IN THE DRAWINGS

REMARKS

Amendments to the Drawings

Fig. 2

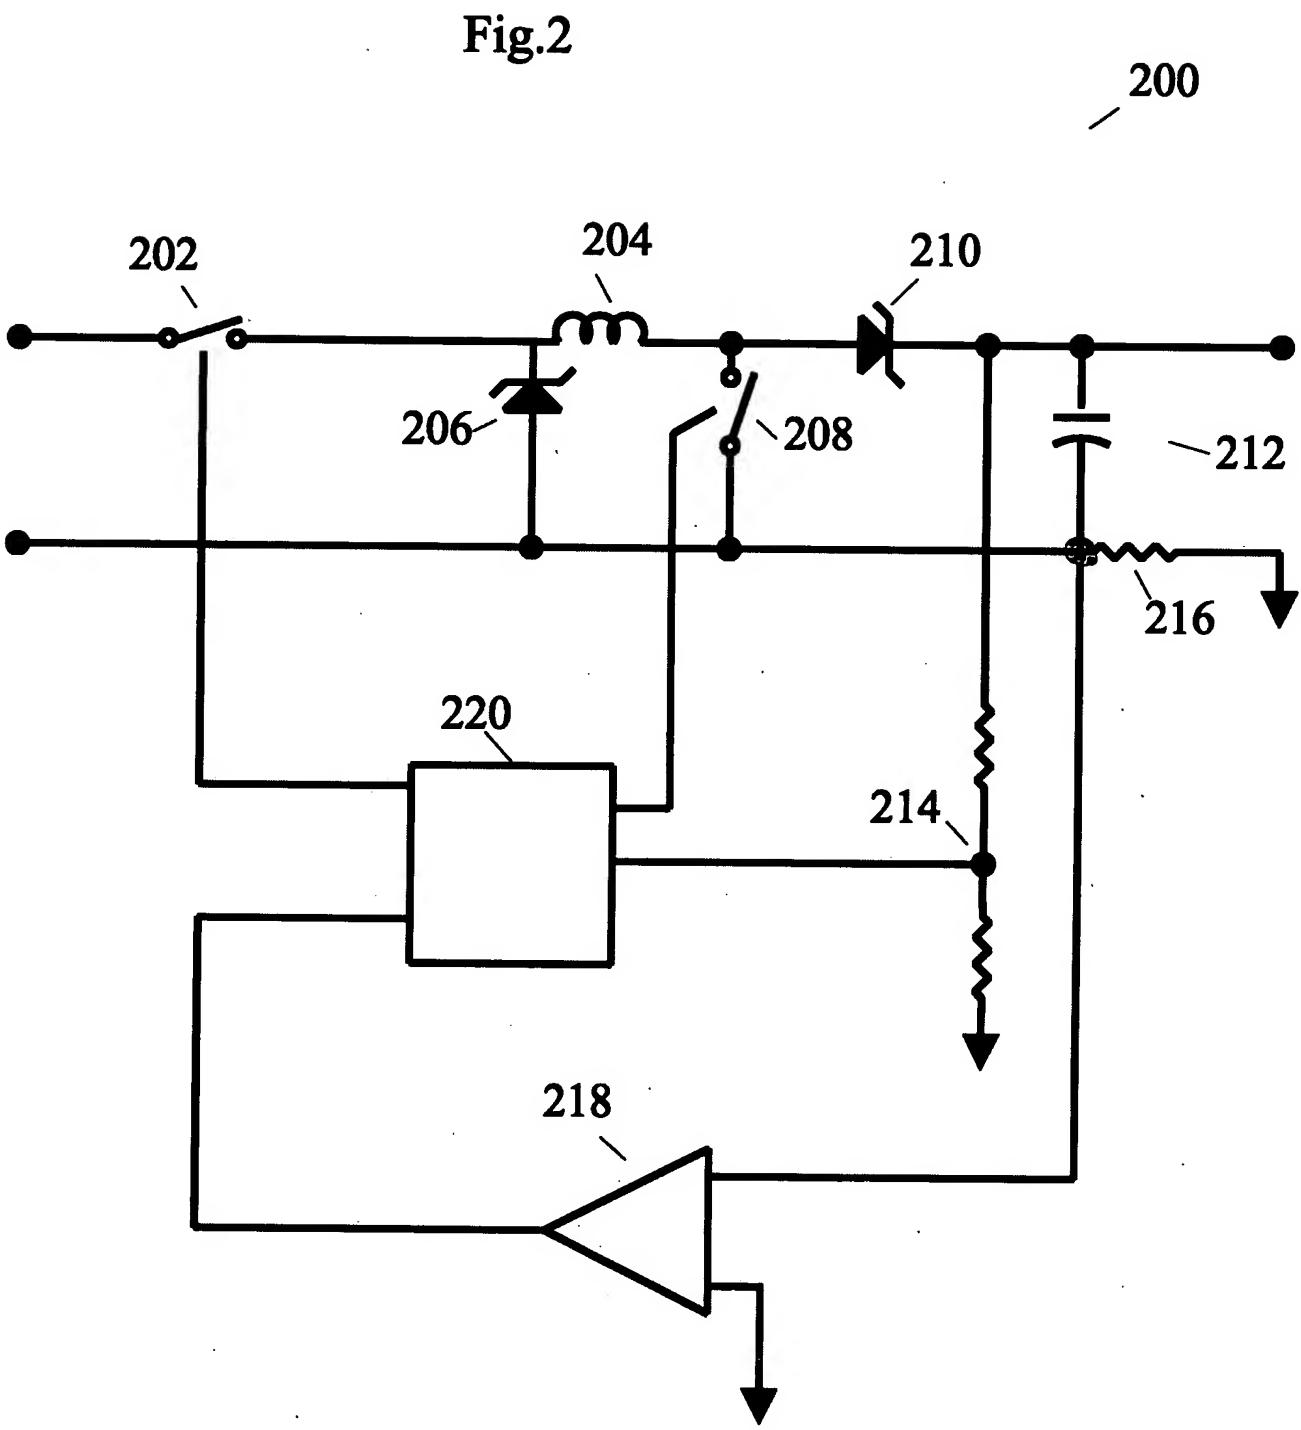
The junction of the wire connected to resistor 216 and the wire connected to capacitor 212 has been clarified by addition of an enlarged dot indicating that the branches are connected.

First, in Figure 2, the junction of the wire connected to resistor 216 and the wire connected to capacitor 212 has been clarified by addition of an enlarged dot to more clearly indicate that the branches are connected. Second, in Figure 5, the junction of the wire connected to motor 406 and the wire connected to capacitor 418 has been clarified by addition of an enlarged dot to more clearly indicate that the branches are connected.

Support for the amendment to Figure 2 appears, for example, in paragraph 0036, which indicates that "current sense resistor 216 and amplifier 218 ... provide feedback to circuit 220 of output current." It is respectfully submitted that one skilled in the art would readily understand that a circuit path is needed from current sense resistor 216 to amplifier 218 for such operation to occur, and would readily understand from inspection that the branches identified above would be interconnected in order to make such a circuit path.

Fig. 5

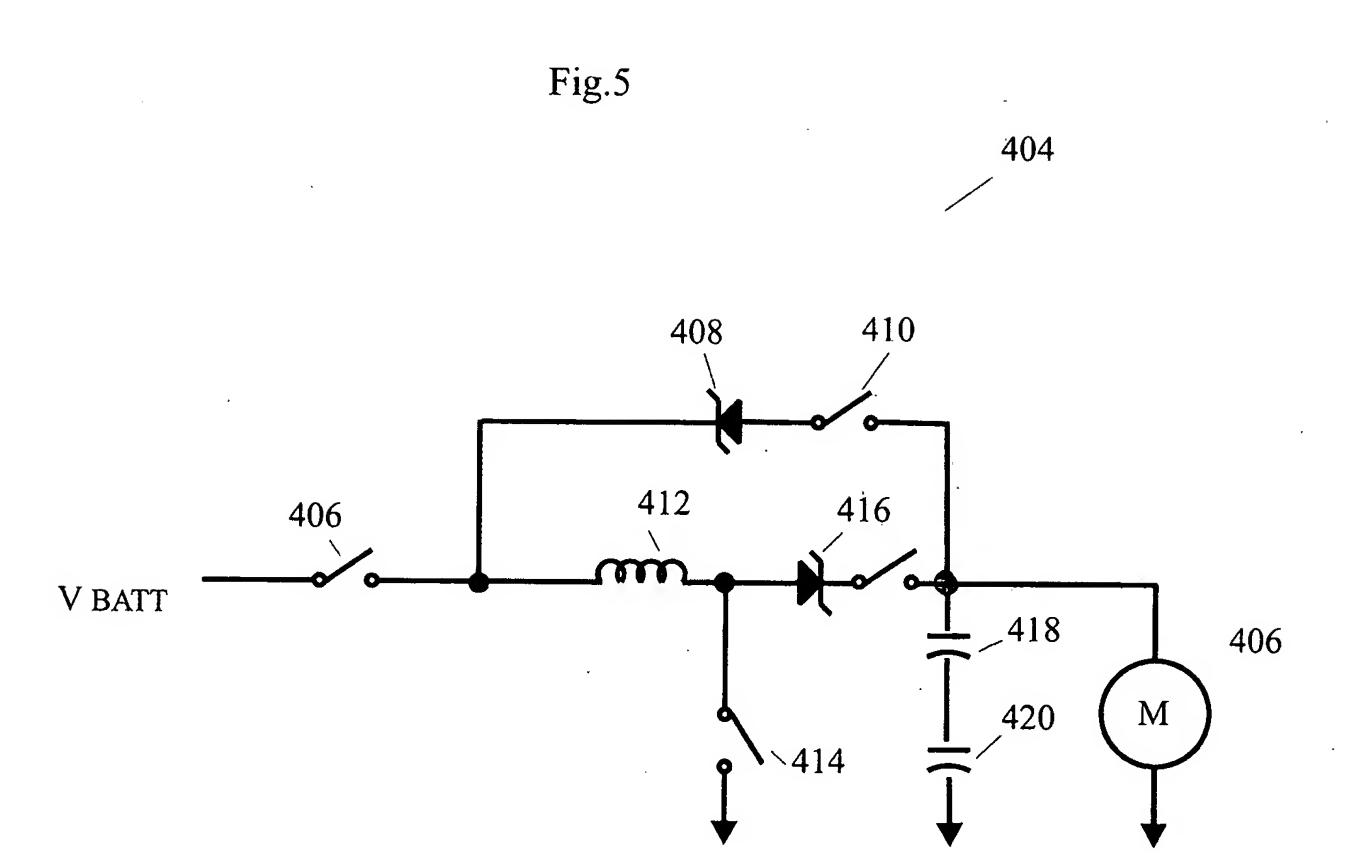
The junction of the wire connected to motor 406 and the wire connected to capacitor 418 has been clarified by addition of an enlarged dot indicating that the branches are connected.

Support for the amendment to Figure 5 appears, for example, in paragraph 0058, which indicates that "[c]apacitors 418 and 420 filter the output to remove ripple from the output voltage." It is respectfully submitted that one skilled in the art would readily understand that a circuit path is needed from voltage output to capacitor 418 for such operation to occur, and would readily understand from

inspection that the branches identified above would be interconnected in order to make such a circuit path. While such connection is understood in original Figure 5, the addition of the enlarged dot merely confirms such a connection.
